DEVELOPMENT REVIEW COMMITTEE (DRC) COMMENT REPORT

PROJECT NAME: The Era

CASE NUMBER: UDP-S23015

REQUEST: Site Plan Level II Review: Mixed Use Development
Consisting of 330 Residential Units, 70 Affordable Units,
and 2,453 Square-Foot of Commercial Use with
Associated Parking Reduction in the South Regional
Activity Center

Exhibit A

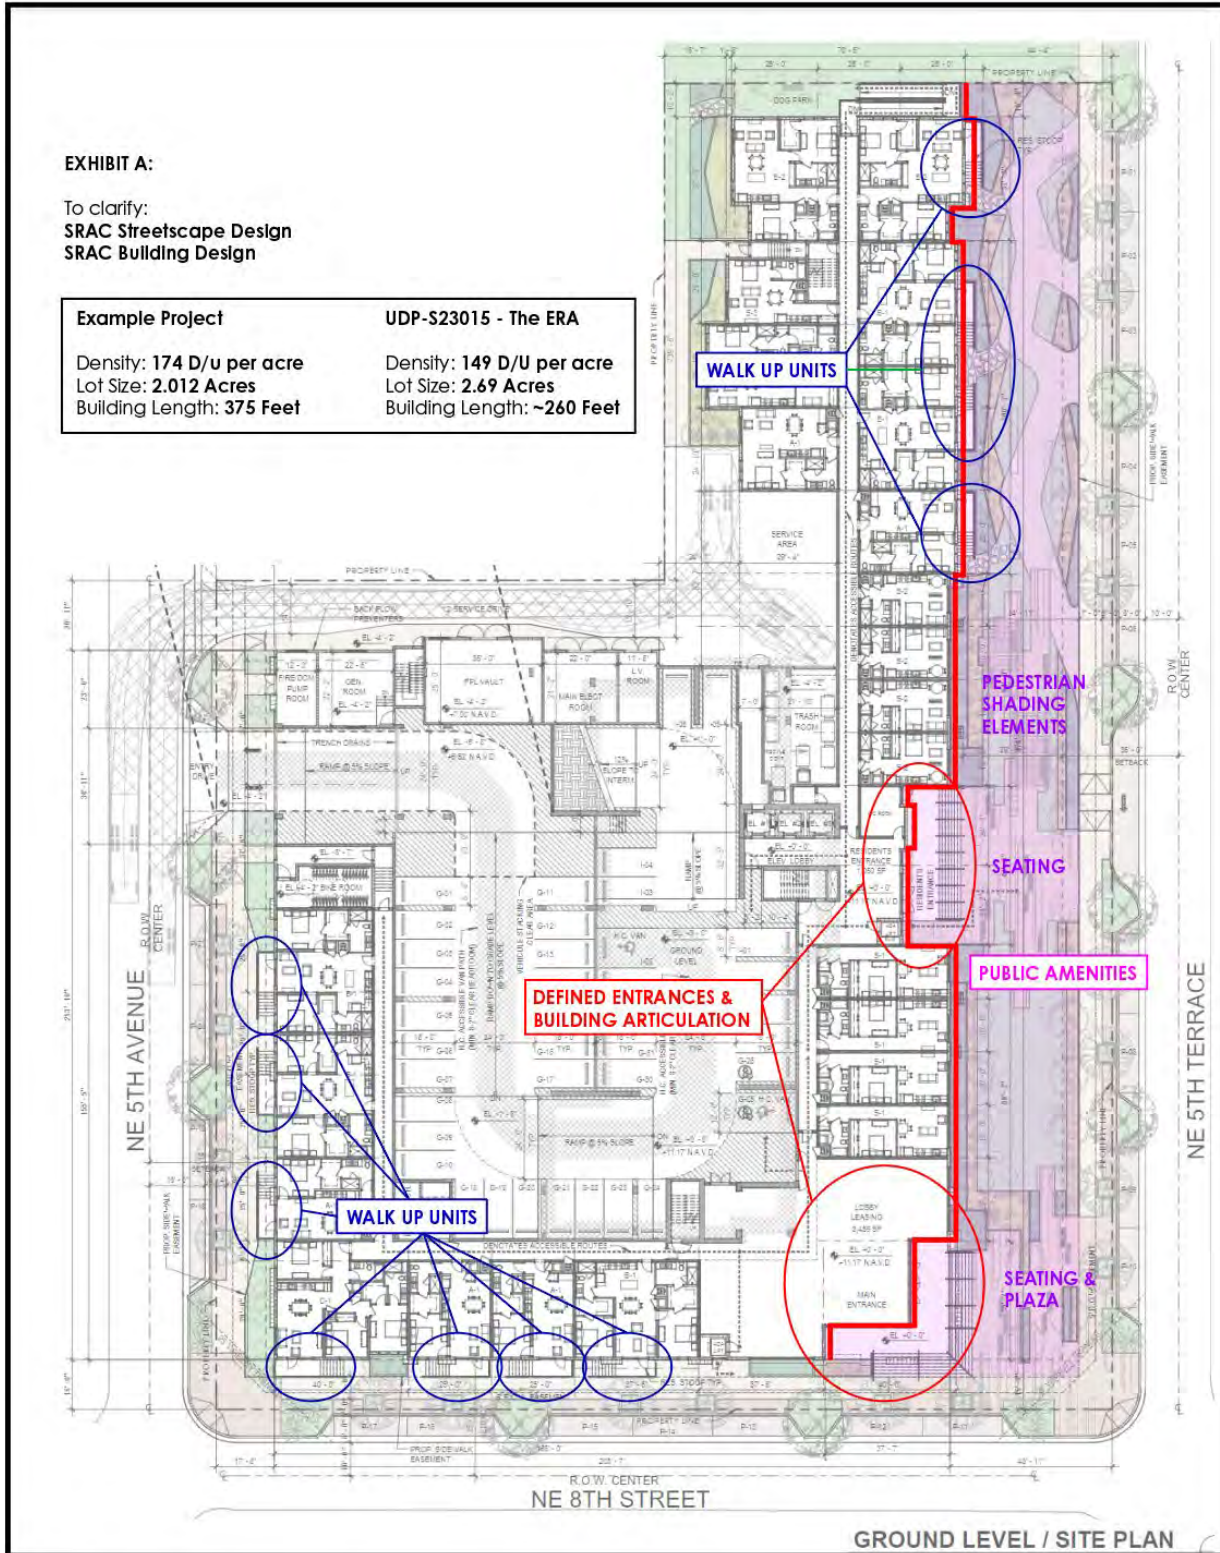
9. As proposed, the building architecture does not meet the design intent in the master plan. There is a lack of building articulation both vertically and horizontally, lack in variety and quality of building materials, there are no pedestrian shading devices, and the ground level unit design lacks individual identity. Address these issues by examining the building design, providing for double story height along portions of the façade, add pedestrian shading awnings, emphasize the building corners, and examine other design solutions. (See below images). Additionally, along the south side of the development, the corner of the building seems to get overwhelmed by the two residential units. Remove the units and enlarge the corner plaza, similar to the corner to the north. See diagram, **Exhibit A**, at the end of the document for further clarification.

- d. S-11) Provide additional streetscape amenity elements such as bike racks, seating, lighting elements, water features, etc. Additionally, provide a detail sheet exemplifying these elements and depict such on the plans. See diagram, **Exhibit A**, at the end of the document for further clarification.

- f. B-4) The south corner plaza does not lend itself to an inviting pedestrian experience. The ground level units, retail space, and public plaza/amenities do not blend together well. See diagram, **Exhibit A**, at the end of the document for further clarification, and example images below.

- l. B-17) The architecture needs to blend into the surrounding context. The building is massive, with no articulation, variation in roofline and height, no functional public pedestrian amenities, vast building walls, and a partially unscreened parking garage. See diagram, **Exhibit A**, at the end of the document for further clarification.

- m. B-18) The streetscape needs to be integrated more holistically with the project to create a continuous public realm frontage. See diagram, **Exhibit A**, at the end of the document for further clarification.

- n. B-22) Provide individual walk-up entrances to the ground floor units. See diagram, **Exhibit A**, at the end of the document for further clarification.
